Lot 117 ✓  
Phase 1  
Model Gabriel (50-5) Elev B ✓  
RASSHELL MCDONALD and RYAN MCDONALD ✓

Colours Upgrade Report  
Brooklin Print Date:17-Apr-13

## FINAL STRUCTURAL REQUEST ACKNOWLEDGMENT

Second Floor Elev. ~~'A'~~ B

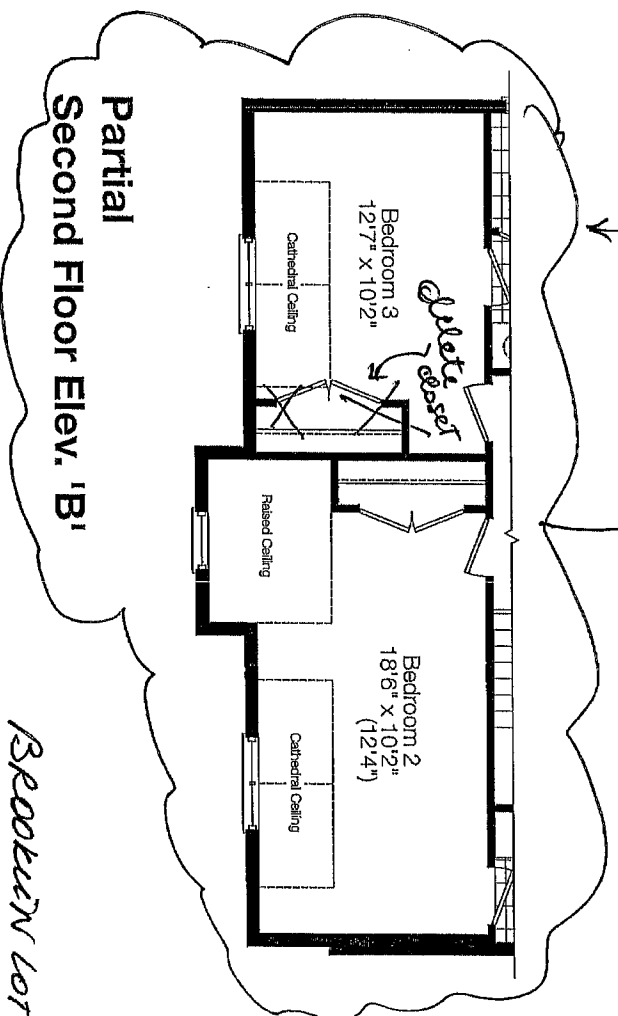
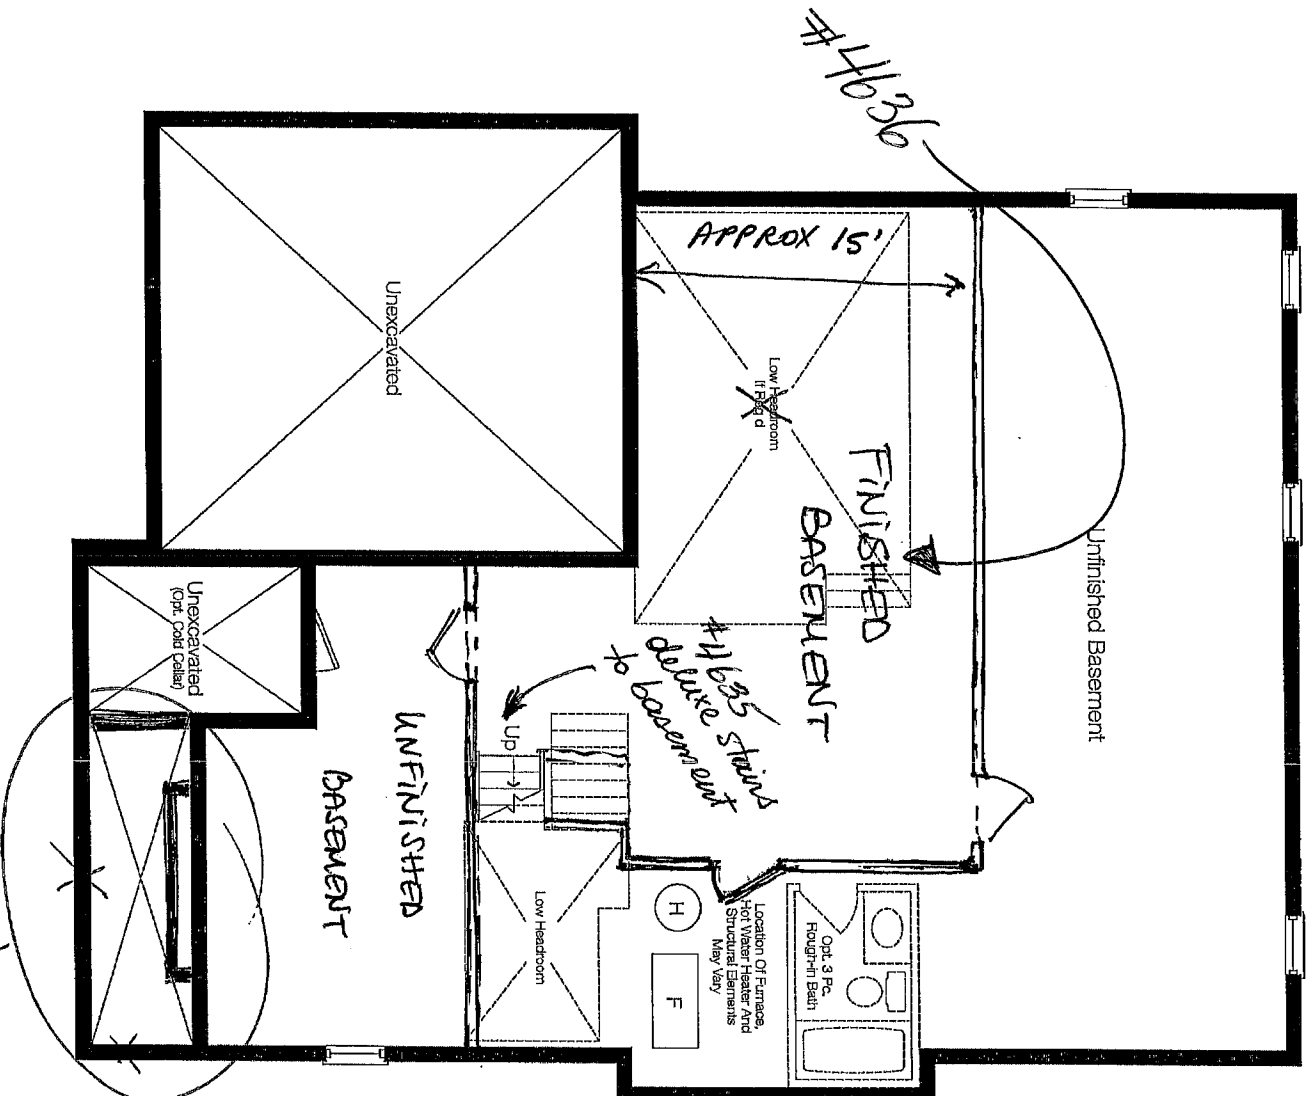
✓ 4443	STRUCTURALS	Master Bedroom: one additional operable window  *See sketch	597		
✓ 4444	STRUCTURALS	Master Ensuite and walk in closet:  Change direction of toilet (drywall beside toilet is a half wall) Delete Make up area rotate both vanities to sit against tub wall Glass shower increase in size with shower seat Walk in closet mini entrance deleted Door added to WIC from bedroom Framed glass shower  *See revised layout	597		
✓ 4445	STRUCTURALS	Master Ensuite: Frameless glass shower	597		
✓ 4446	STRUCTURALS	*****CANCELLED ON PES 619 - SEE ITEM 4634 & 4635 Main to basement: Open staircase  Remove door at top of basement stair, Upgrade stair to oak natural finish. Includes painted drywall finished walls on both ide of stair with oak rail, 4 x 4 tile landing at base of stair with door to unfinished basement. From builders standards.	597		
✓ 4447	STRUCTURALS	Tankless hot water tank  *Price for plumbing rough in	597

✓ 4448	STRUCTURALS	All bathrooms: no mirrors or bathroom accessories	597		
✓ 4449	STRUCTURALS	Dining Room: Square off coffered ceiling, no angles to be installed	597		
✓ 4450	STRUCTURALS	*****CANCELLED ON INVOICE 619 - SEE ITEM 4632 Family Room: Move fireplace to side wall *Single sided	597		
✓ 4451	STRUCTURALS	*****CANCELLED ON INVOICE 619 - SEE ITEM 4632 Family Room: Extend nib wall 2 ft on each side *Delete STD fireplace wall *Flat arch to remain due to waffle ceiling, arch to be 8 ft	597		
✓ 4452	STRUCTURALS	Breakfast room: French door upgrade with SCREEN  Delete sidelights Do NOT DELETE TRANSOM window	597		
✓ 4453	STRUCTURALS	Breakfast room: Move French door down approx 1ft. towards family room  Purchase would like one side of the french door to be lined up with main hallway	597		
✓ 4454	STRUCTURALS	Dining Room: Delete columns	597		
✓ 4455	STRUCTURALS	Main floor: increase height of all archways to 8 ft  closet doors powder room door laundry room door den door	597

✓ 4456	STRUCTURALS	Increase the height of doors on main floor	597	*	CLOSET, POWDER, LAUNDRY, DEN DOORS
✓ 4457	STRUCTURALS	Laundry room: change swing of door  *See sketch	597		
✓ 4632	STRUCTURALS	Delete Item #4450 and 4451  Double sided fireplace to be installed with walls as per STD plan	619		
✓ 4633	STRUCTURALS	Delete item 4442  basement window to be installed as per STD plan	619		
✓ 4634	STRUCTURALS	Delete item 4446	619		
✓ 4635	STRUCTURALS	Add Open to below staircase DELUXE  Create an open to below stairwell. Upgrade stair to oak natural finish with open stringer and railing.  **Basement stair opening and stair width to allow for railings on both sides of stairs to basement  Includes finished landing (approx) 10 x 10 at base of stair with doors to unfinished basement.	619	*

## Basement Floor Elev. 'A'

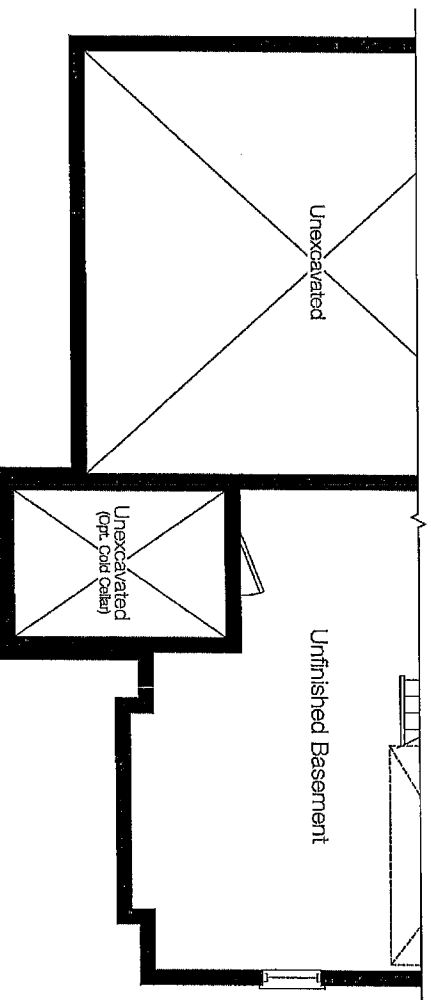
ID	Group	Description	Invoice	Date Ordered	
✓ 3868	50 FOOT BONUS	DELETE 3 HIGH WINDOWS IN FAMILY ROOM	518		
✓ 3869	50 FOOT BONUS	(2X) 24 X 62 OPERABLE WINDOWS IN DINING ROOM INSTEAD OF SINGLE WINDOW	518		
✓ 3870	50 FOOT BONUS	IF POSSIBLE DO NOT SINK DEN AND LAUNDRY ROOM	518		
✓ 3871	50 FOOT BONUS	DELETE MIDDLE WINDOW IN MASTERBEDROOM	518		
✓ 3872	50 FOOT BONUS	REVISE TWIN BATHROOM TO ACCOMODATE CLOSET IN BEDROOM 3 *DELETE CLOSET IN BEDROOM 4 *PUSH TUB, TOILET AND WINDOW IN TWIN BATHROOM INTO CLOSET (BED 4) LOCATION *RELOCATE CLOSET IN BEDROOM 3	518		
✓ 4100		SHIFT WALL BETWEEN LAUNDRY ROOM AND DEN 2 FEET INTO DEN TO MAKE LAUNDRY ROOM WIDER	546		
✓ 4101		OPTIONAL DOUBLE SINKS IN TWIN BATHROOM	546		
✓ 4102		STANDARD UPPER CABINETS IN LAUNDRY ROOM	546		
✓ 4103		DELETE HALF WALL AND INSTALL STANDARD HANDRAIL AND PICKETS AT UPPER COMPUTER LOFT TO STAIRS	546		
✓ 4442	STRUCTURALS	*****CANCELLED ON PES 616 - SEE ITEM #4633 Basement: Move window to new location *See sketch	597

✓ 4636	STRUCTURALS	Option 4 Finished basement sketch  *See sketch *includes low wall return vents where needed *Electrical per code *Trim and drywall paint *Smooth ceilings included	619		
✓ 4637	STRUCTURALS	Family Room: archways to be trimmed as per photo provided by purchasers and installed tight to walls. Arch to be 8 ft.	619		
✓ 4638	STRUCTURALS	Master WIC: Move wall back 1ft. which in turn will increase Ensuite 2. This will allow for approx 4ft vanity	619		
✓ 4639	STRUCTURALS	Main hall to kitchen: increase arch by 1ft width  *Pending arch control if laundry room is not sunken	619		
✓ 4640	STRUCTURALS	Bedroom 4: Delete STD window and install 2 seperate windows 24 x 48 Window to be installed 8 inches from wall on each end. *See sketch	619		
✓ 4644	CLARIFICATION	**PLEASE NOTE: There may be low headroom if it is required where the purchaser wants the 15x12 room in the finished basement. Because this lot hasnt been sited yet we dont know if it will be sunken on the main floor or not.	621
